UNITED STATES PATENT AND TRADEMARK OFFICE

APPLICATION NO.	FILING DATE	FIRST NAMED INVENTOR	ATTORNEY DOCKET NO.	CONFIRMATION NO.
10/800,294	03/12/2004	Bjorn Paulshus	7822-91660	8246

Office Action Summary

Paulshus, WO 98/39532

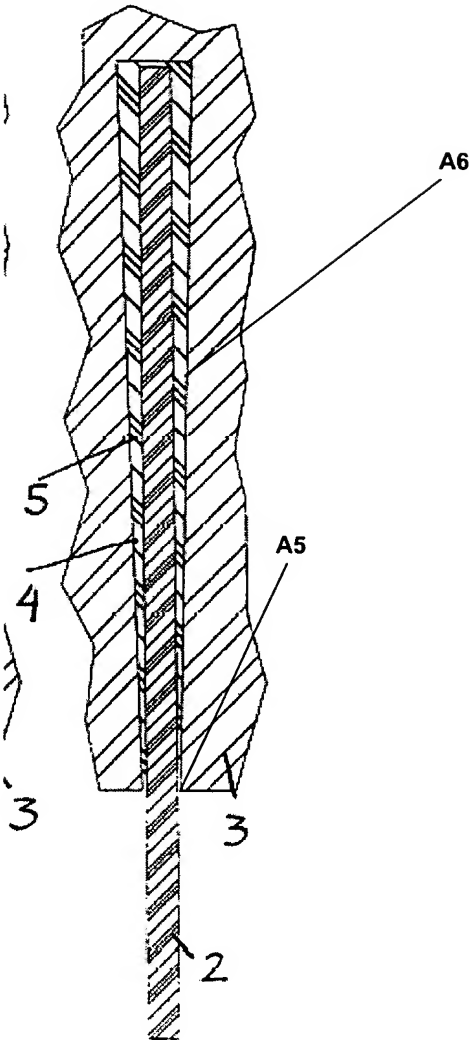
Regarding claim 22, Paulshus discloses, a termination of one end of a tension member **1** comprising multiple strands **2**. The strands **2** comprise fibers selected from the group consisting of carbon fibers, aramid fibers, and glass fibers (see page 3, lines 19-21) and the fibers having a lower shear force and durability than steel (see page 2, lines 12-15). A transitional zone (near reference **10** in Fig. 4) in the tension member **1** where the strands **2** are spread apart. At least one receiving body **3**. Each of the strands **2** in the transitional zone **10** are inserted into a narrow end **A5** of a respective conical hole **A6** in the at least one receiving body **3** and fixed in relation to the hole by a hardened mass **5**. However, Paulshus fails to disclose the wall of the conical hole **A6**

having a slip agent applied thereto such that the hardened mass **5** is prevented from adhering to the wall.

Regarding claim 26, the strands **2** are anchored in the holes **A6** in the receiving body **3**, and the holes **A6** are arranged in at least one ring around a center of the receiving body **3**. Note that Figure 4 shows several holes around a center of the receiving body **3**.

Regarding claim 27, the holes **A6** taper inward in a direction towards the tension member **1**.

Regarding claim 33, the holes **A6** comprise an increasing cross section in the direction away from the tension member **1**.
